Title: 2015+ N13 Cylinder Pack - Update for Excessive Lubrication Oil Consumption

Applies To: 2015+ N13 ESN: 4400000-4401769

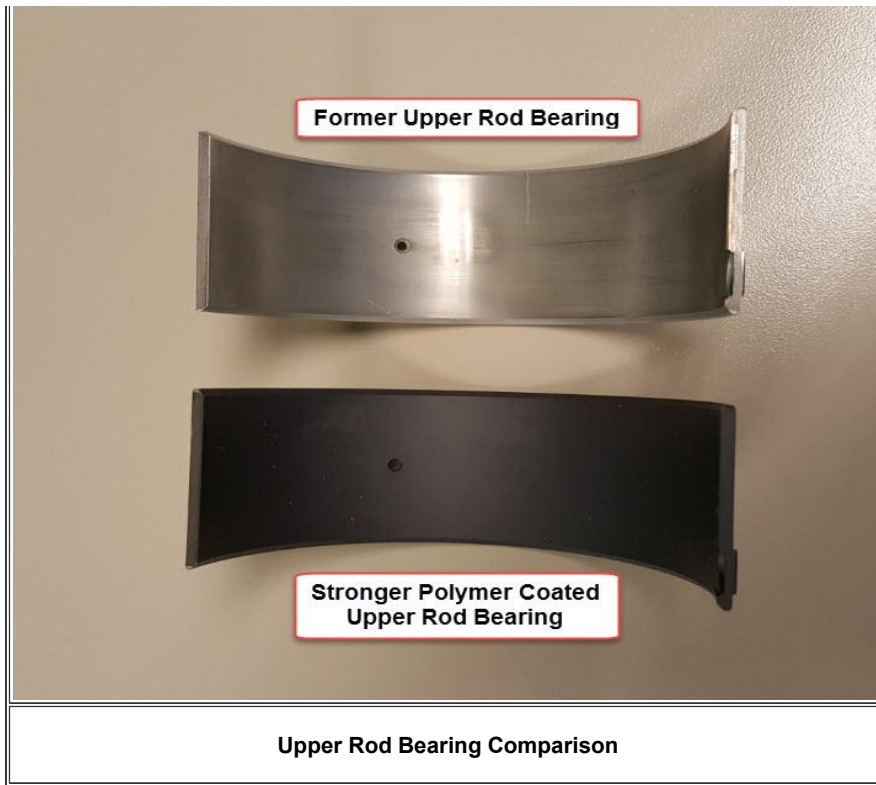
An updated cylinder kit is now available to address this condition. The updated liner integrates a removable "anti-polish" carbon scraping ring which sits in a machined counterbore. This anti-polish ring (APR) has a smaller internal diameter than the rest of the liner that allows it to scrape carbon off of the top land of the piston during normal operation. This action of continuously removing carbon buildup from the top land of the piston prevents the rings from carbon packing and losing oil control in the power cylinders.

APR liners cannot be mismatched with standard liners. If for any reason an APR liner needs to be installed in an engine with standard liners, all 6 liners will need to be updated to the APR liners.
